**NOTICE OF SPECIAL MEETING AGENDA
HISTORIC LANDMARK PRESERVATION COMMITTEE
MUNICIPAL CENTER CITY COUNCIL CHAMBERS
211 N. HENRY STREET, LANCASTER, TEXAS**

2. HLPC20-11 Discuss and consider a Certificate of Appropriateness (COA) for the construction of a 3,113 square feet home on the property addressed as 415 South Dallas Avenue, Lancaster, Dallas County, Texas.

HLPC20-11 Discuss and consider a Certificate of Appropriateness (COA) for the construction of a 3,113 square feet home on the property addressed as 415 South Dallas Avenue, Lancaster, Dallas County, Texas.

EAST ELEVATION
SCALE: 1/4" = 1'-0"

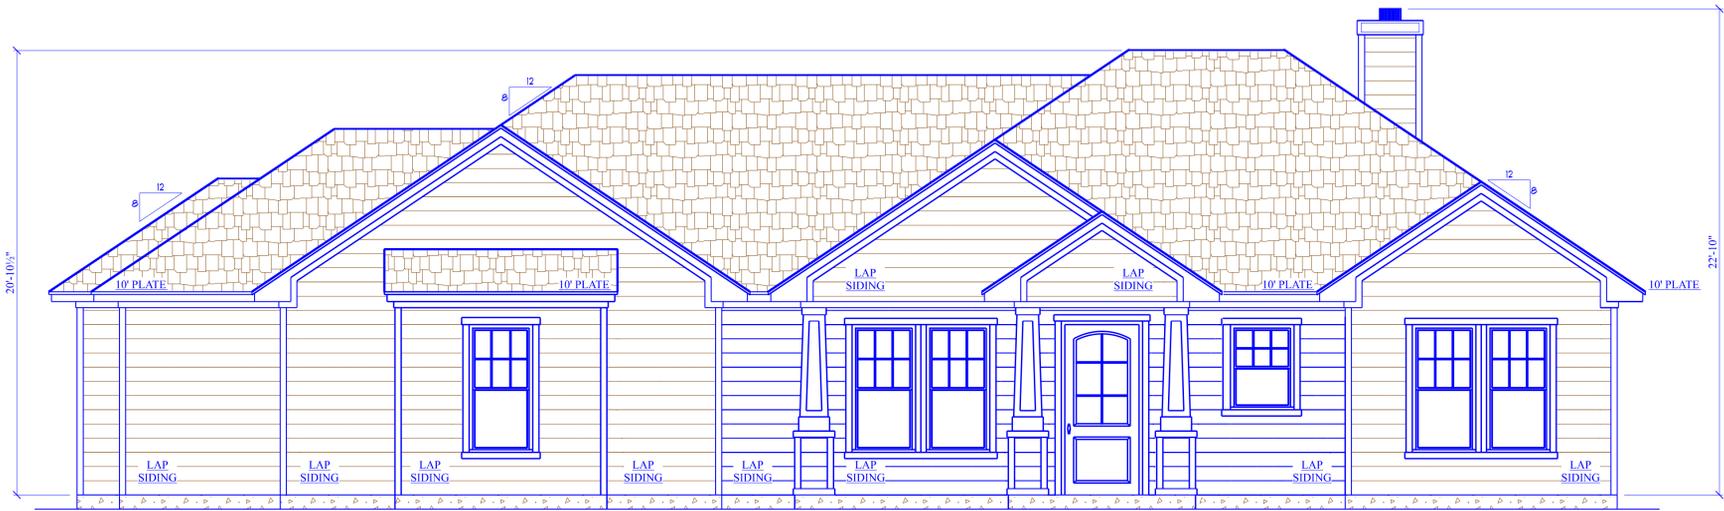
Vice Chair Siegfroid-Giles expressed concern over the lack of Craftsman features on the home. She said Craftsman style windows are usually double hung, four or six over one, in pairs, and stated that vinyl windows were inappropriate for a Craftsman home. She said the applicant had gables, overhanging eaves and columns but the columns lacked necessary detail.

Chair Hooper asked if the six over one windows on the street elevation will be on the rest of the home. Mr. Chapman stated that the six over one window will only be on the street elevation of the home, and a different window will be used on the back of the house.

According to Section 3.3.3 *New Windows* of the LHRDR, Craftsman style windows on houses are often grouped in pairs "New windows shall be wood...Do not use metal, vinyl or other materials...a variety of roof forms such as hipped and gable are often used for Craftsman styled homes...walks and drives for Craftsman styled homes were typically straight and made of concrete....and new doors should be made of wood..." The proposed home will have a hipped roof form and the door will be made of wood. The front walk and driveway will be straight and made of concrete. The proposed windows will be grouped in pairs but will be made of vinyl. The proposed roof form, driveway, front walk, and orientation of the windows meet the design standards for a Craftsman style home. However, the proposed vinyl windows are in direct conflict with the LHRDR which prohibits the use of vinyl on new windows.

Staff recommends approval of the request to construct the new home and denial of the request to use vinyl windows on the home.

NORTH ELEVATION
SCALE: 1/4" = 1'-0"

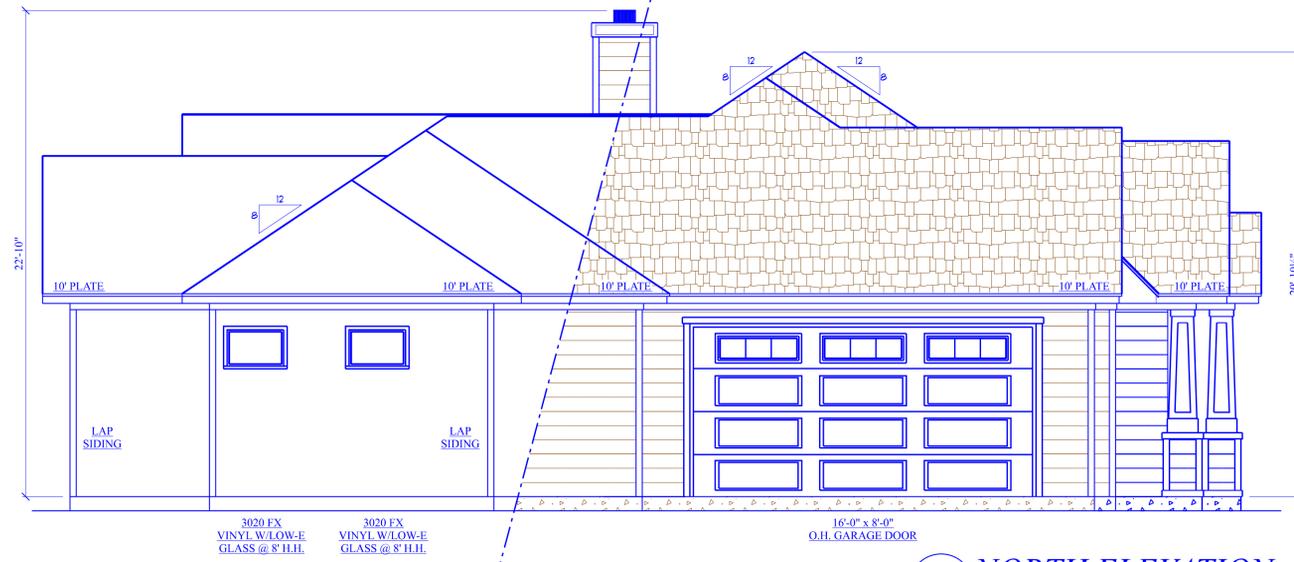
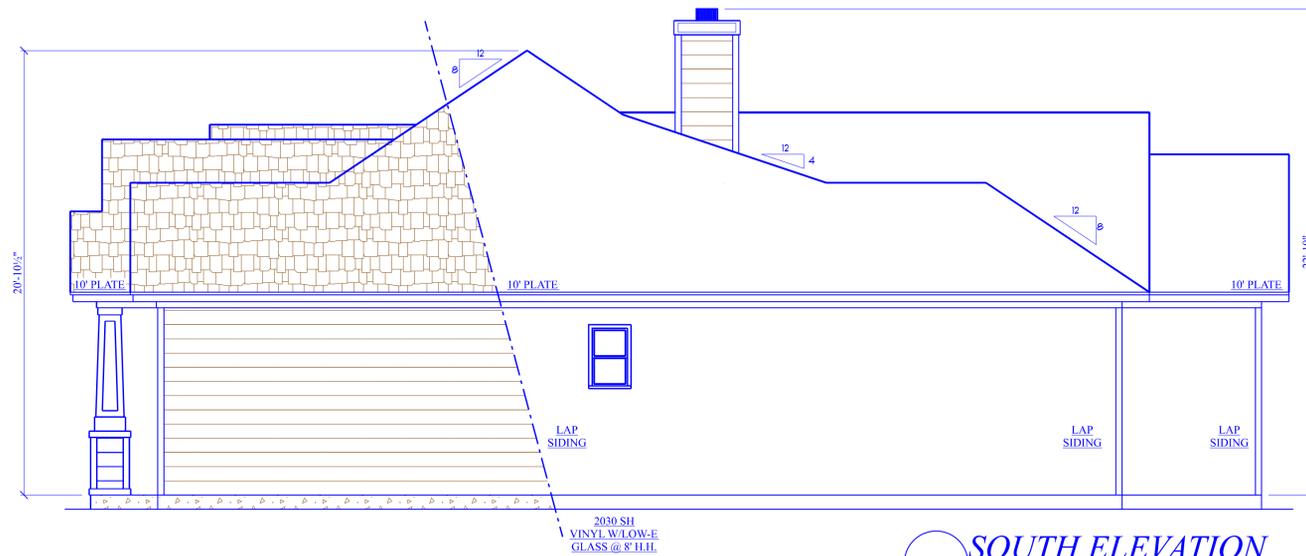
The proposed home will use smart wood siding (wood strands that are coated with a resin binder and compressed to create a board) and its exposure reflects traditional lapped wood siding. Two (2) of the other surrounding homes are composed of wood or material similar to wood. Although approval of exterior colors is not required through the Certificate of Appropriateness process, it is recommended that Craftsman style homes have earth colors". The home will be painted white.

Update Since Last Meeting: The applicant has updated their application with a color palette demonstrating colors that will be used on the new home and it is attached. The colors are in compliance with the LHRDR.

Example of Proposed Window from Outside

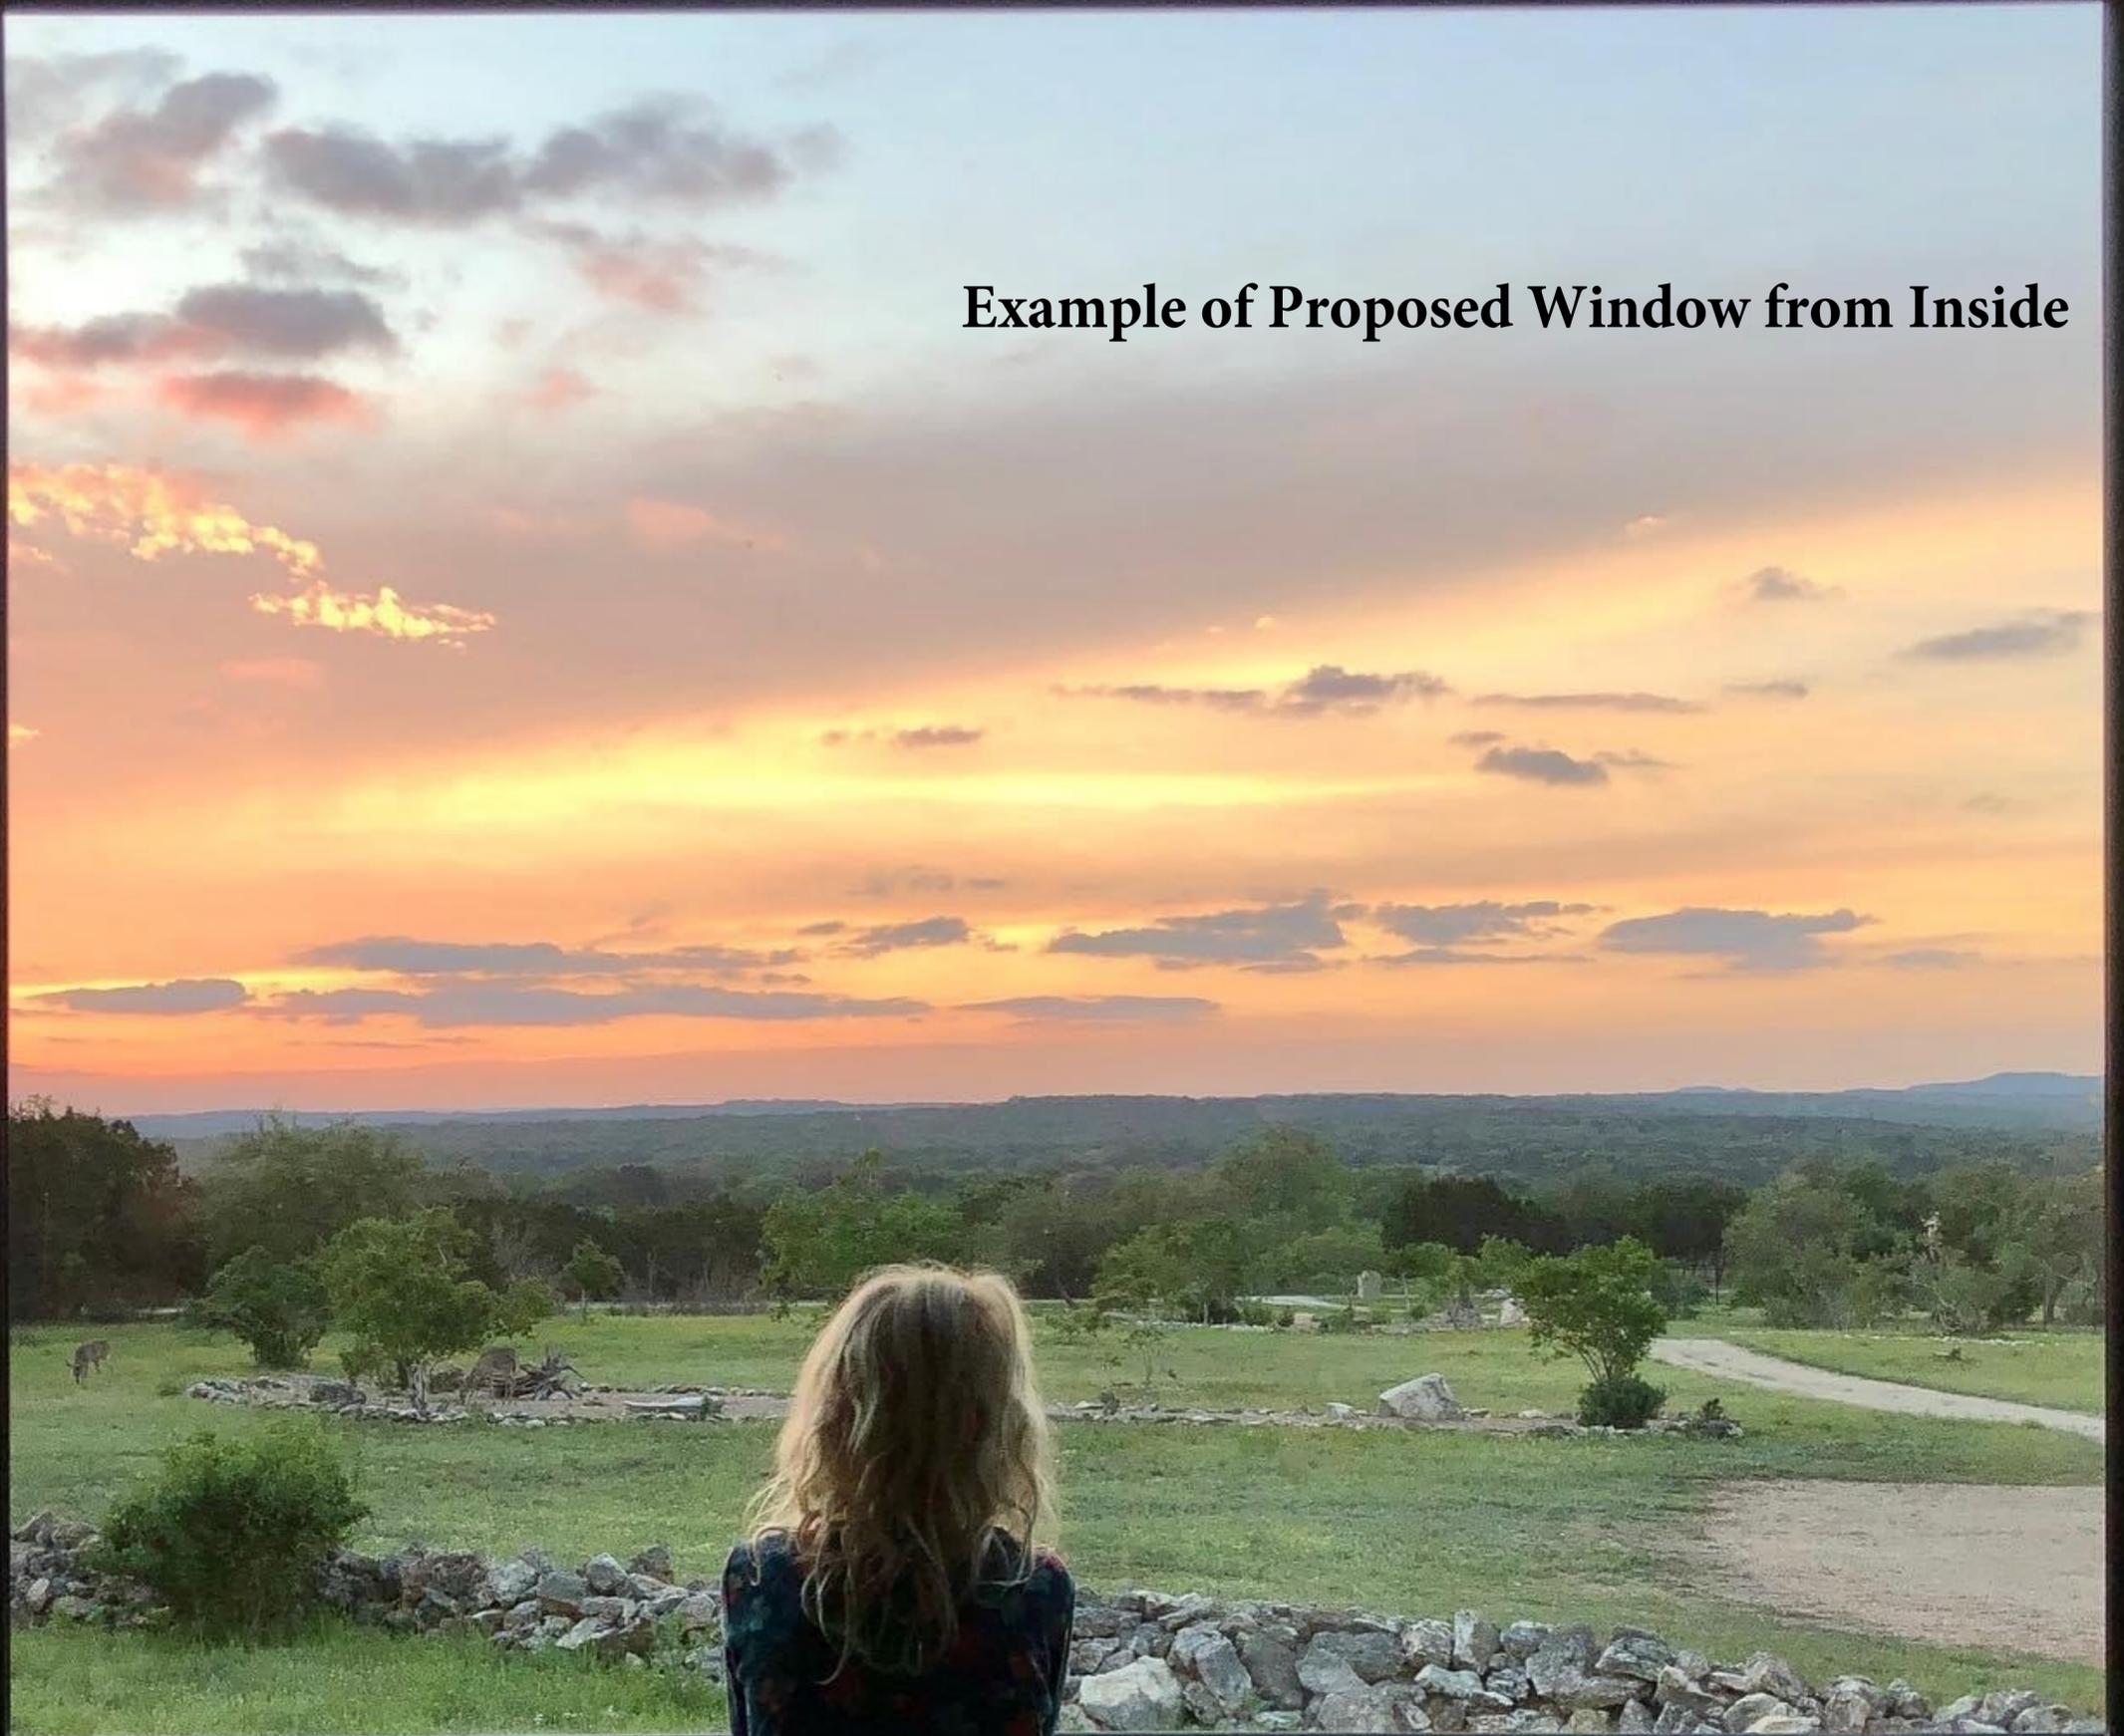
The applicant is requesting to replace eight (8) aluminum framed windows with Fibrex® framed windows as shown on the attached window specifications. According to Andersen Windows and Doors, Fibrex® is a combination of wood and thermoplastic polymer which is low-maintenance, has a low-luster finish, resists decay, is twice as strong as vinyl, and is 700 times more efficient than aluminum with regard to reducing heating and cooling bills. The applicant is requesting to replace the existing windows to make them more energy efficient. The size of the window openings will remain the same.

Staff recommends approval of the request to replace eight (8) aluminum windows with Fibrex® on the subject property.
